Olive Downs Coking Coal Project

Additional Information to the
Environmental Impact Statement

Section 16

Transport

Figure 16-1

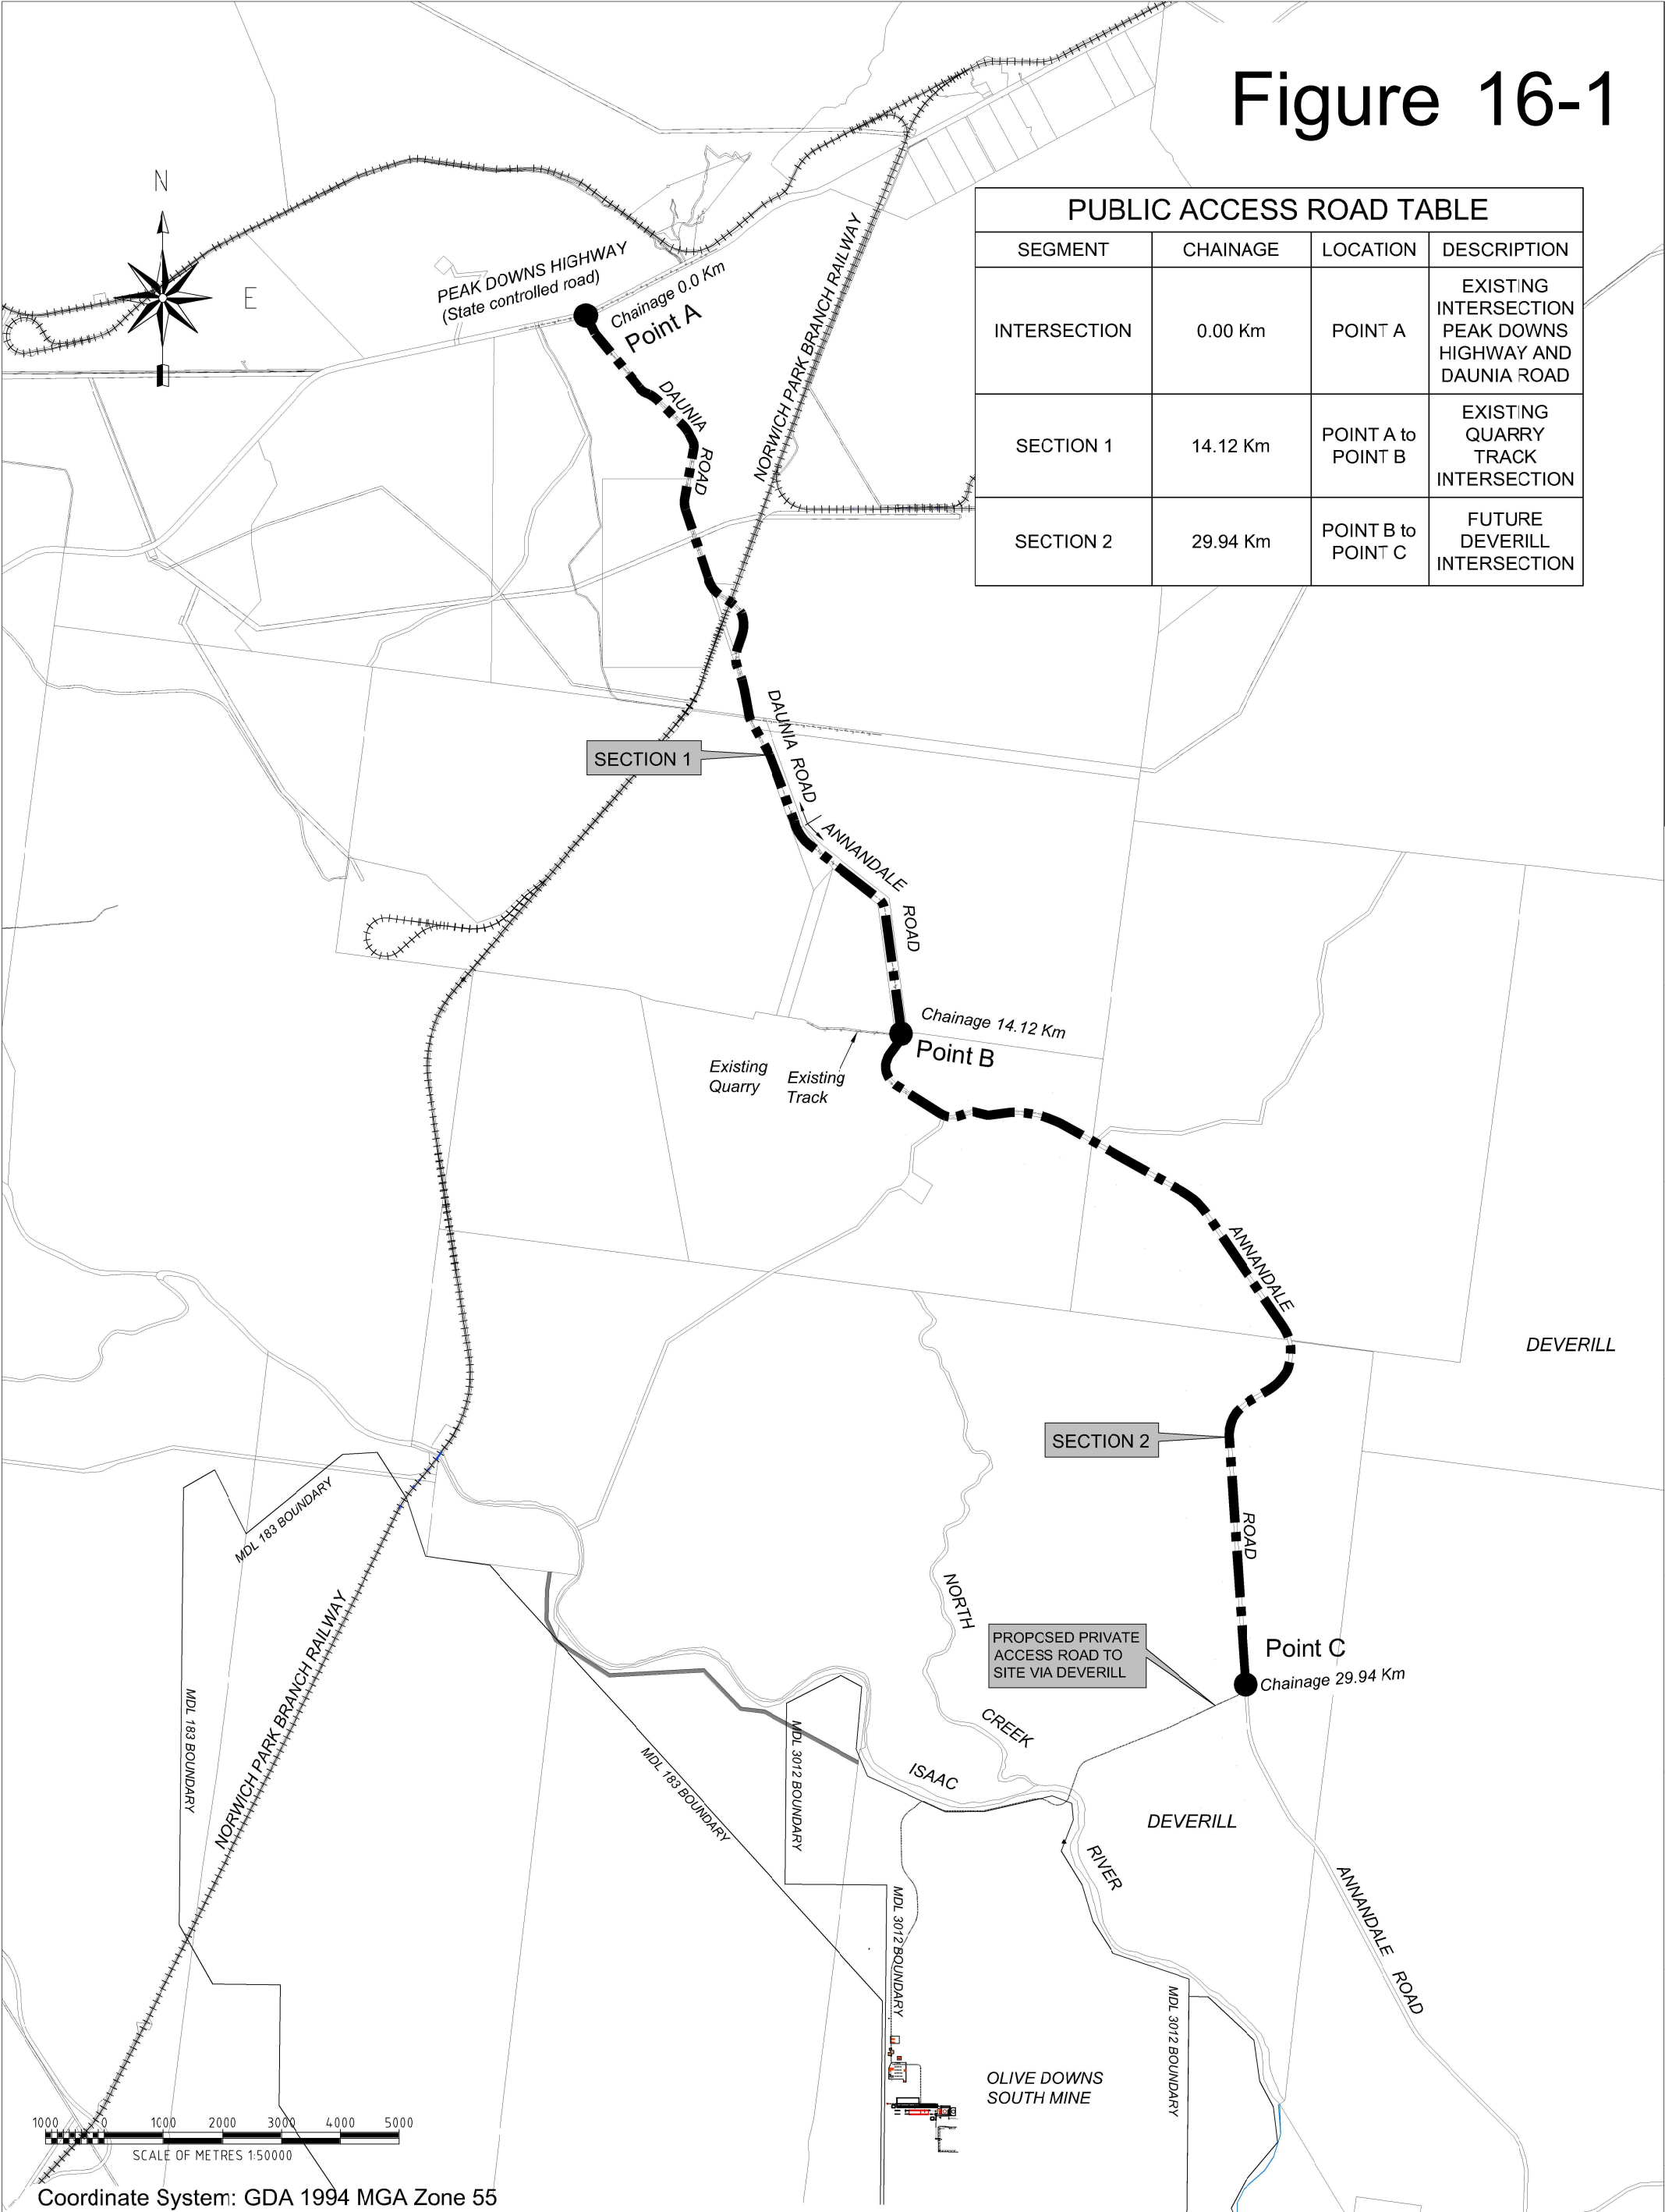
1. *Provide further information on the proposed upgrades of Daunia and Annandale Roads, including maps, detailing the location and details of upgrades proposed, and clarity on the proponent's position regarding the responsibilities for undertaking and financing the road works.*

At the time of writing, the IRC has engaged Projex Partners to undertake detailed designs for first 21 km of proposed upgrades. The proposed Daunia and Annandale Road upgrades have been designed with the following parameters:

- design speed of 110 km/h;
- 1% AEP flood immunity;
- 10 m wide sealed road comprising two 4 m wide traffic lanes with 1 m wide shoulders;
- pavement life of 20 years;
- certain sections of road will be realigned to accommodate the proposed design speed; and
- the road will be fully fenced on both sides to prevent stock entering.

Conceptual road upgrade designs developed by Projex Partners, and provided to the IRC, are shown on Figures 16-1 and 16-2.

Figure 16-3

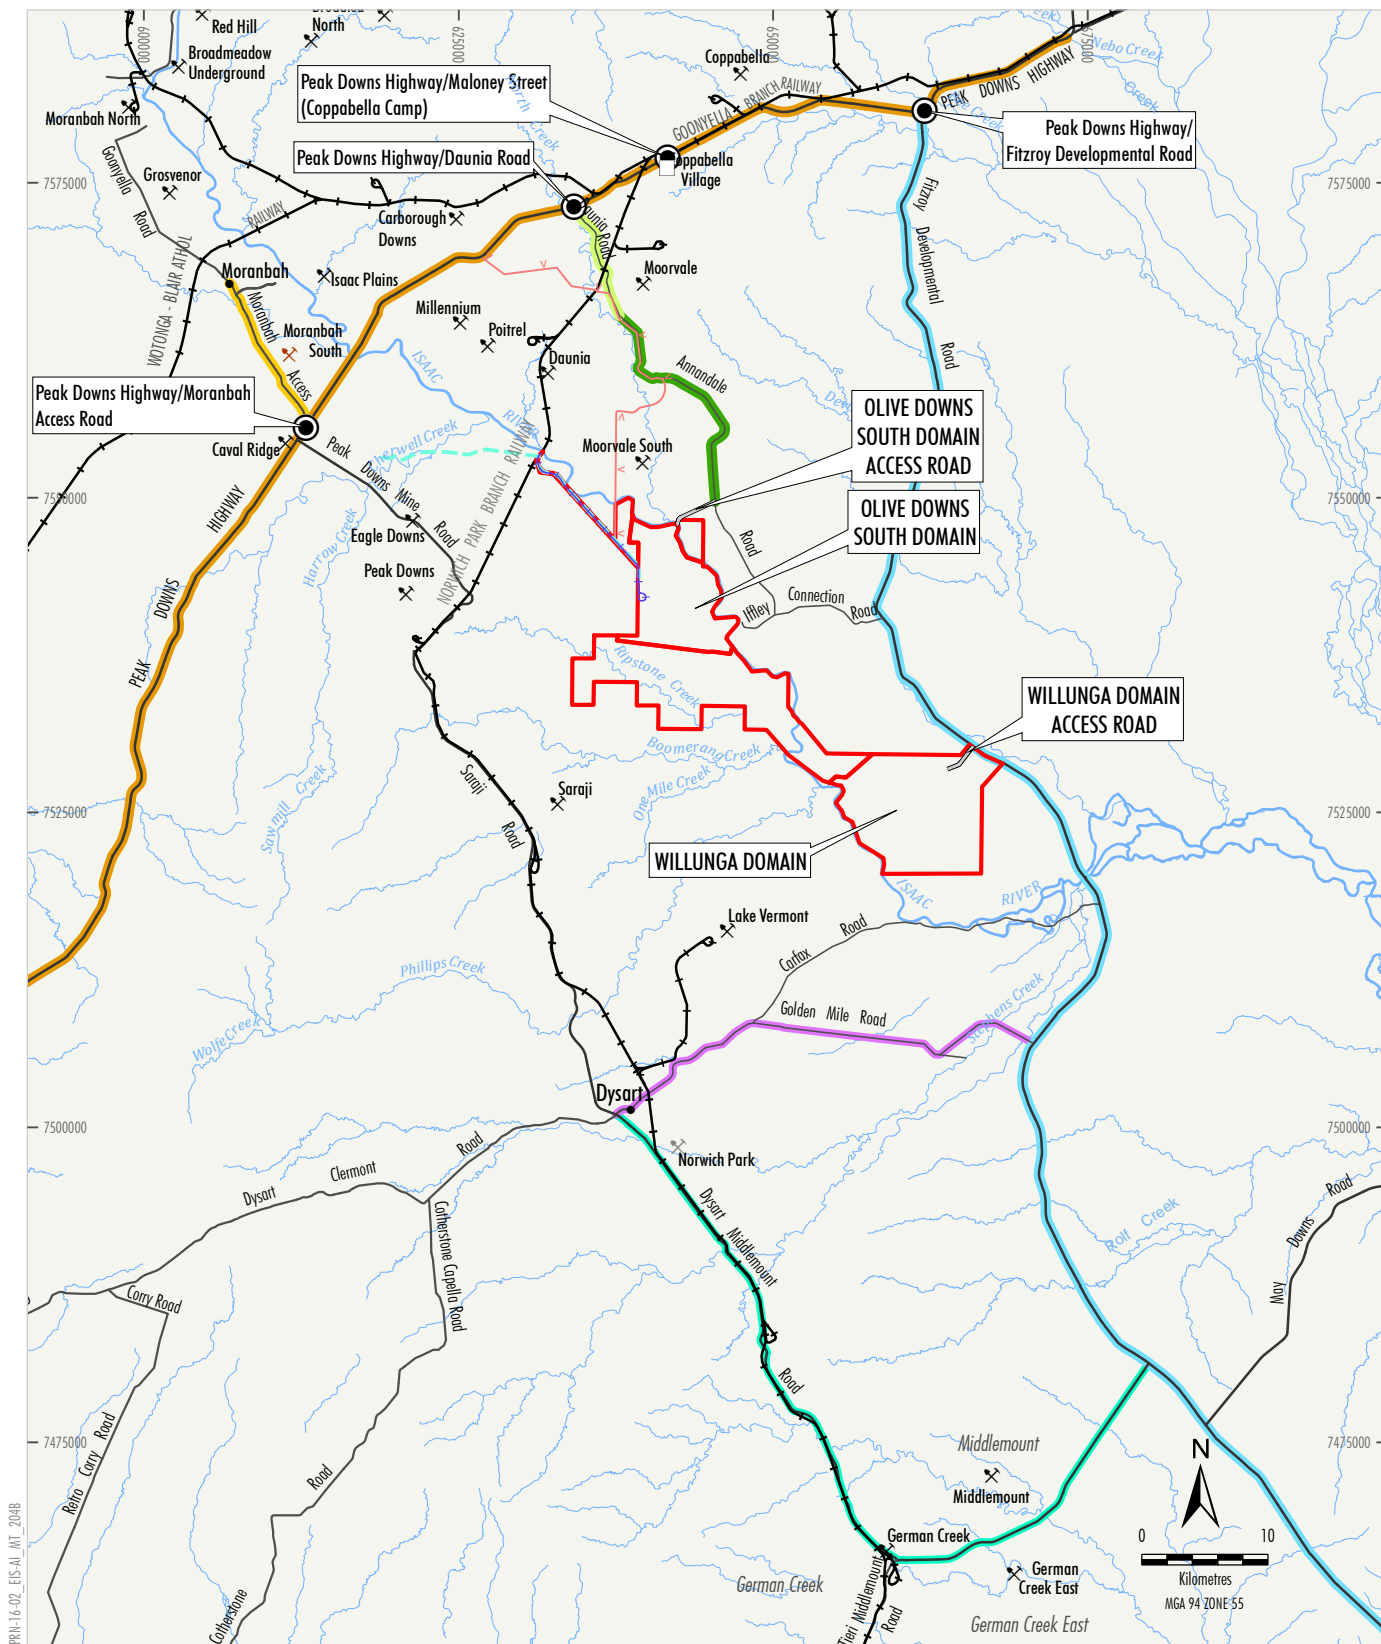
2. *Clarify the expected volume of traffic travelling to the site from the south and the impact of this traffic on affected roads (e.g. roads from Dysart/Middlemount).*

3. Provide an assessment of traffic impacts on Annandale Road (south of the proposed Olive Downs South Access Road), Iffley Connection Road and Vermont Park Road, considering IRC's advice that these roads are expected to be impacted by DIDO traffic.

For those personnel travelling from Middlemount and Dysart, it is expected that the following roads would be utilised (Figure 16-3):

- Dysart Middlemount Road (for traffic travelling from Middlemount [i.e. 87 when the Project workforce reaches its maximum]);
- Golden Mile Road (for traffic travelling from Dysart [i.e. 151 persons when the Project workforce reaches its maximum]); and
- Fitzroy Developmental Road (for traffic travelling from Middlemount and Dysart [i.e. 238 persons when the Project workforce reaches its maximum]).

As shown on Figure 16-3, Pembroke does not propose to utilise Annandale Road (south of the proposed Olive Downs South access road), Iffley Connection Road or Vermont Park Road for any Project related traffic.

As outlined in response to Item 3 above, Pembroke does not propose to utilise Iffley Connection Road for any Project related traffic (Figure 16-3). As such, anticipated traffic using the Fitzroy Developmental Road/Iffley Connection Road and Iffley Connection Road/Annandale Road intersections would only be related to through traffic (i.e. no Project traffic would be turning at these intersections).

Similarly, with respect to the intersections along Carfax Road, Project traffic would be limited to through traffic as Pembroke does not propose to utilise Carfax Road for any Project related traffic (Figure 16-3). Carfax Road (an unsealed road) is approximately the same length as Golden Mile Road (along the route to the Project from Dysart), however, as Golden Mile Road is sealed, anyone travelling along this route is expected to use Golden Mile Road as it would allow for safer, more efficient travel compared to Carfax Road.
